Product Change Notification

Change Notification #:	111211 - 01
Change Title:	Intel PRO/1000 MT Server Adapters, PWLA8490MT/MTBLK5 (Everson Retail) and Intel PRO/1000 GT Quad Port Server Adapters, PWLA8494GT/GTBLK/GTG1P20 (Kingsport 3 LF Retail/OEM generic) PCN 111211-01 Label OUI block change PCN revision, Customer Ready to Receive date change from Jan 19, 2011 to Jan 19, 2012.
Date of Publication:	December 27, 2011

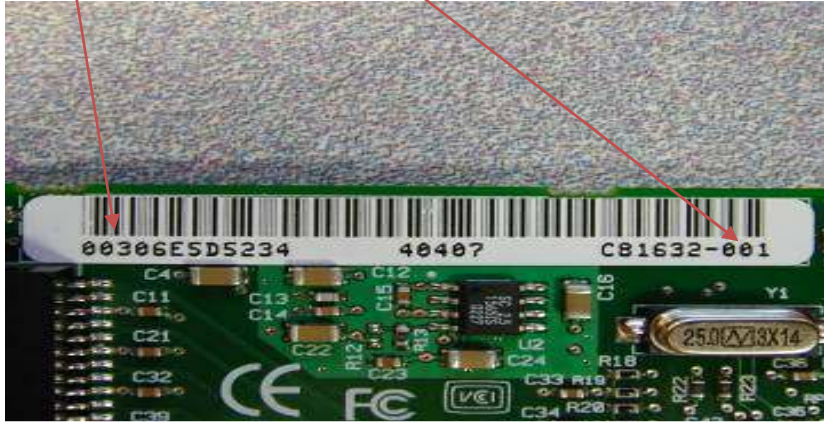
3n1 label change: The 3n1 label will change to reflect the new OUI Block number and PBA# dash roll (printed board assembly), as show in the picture below. The 3n1 label is placed on the Front side of the Printed Board. (picture example only)
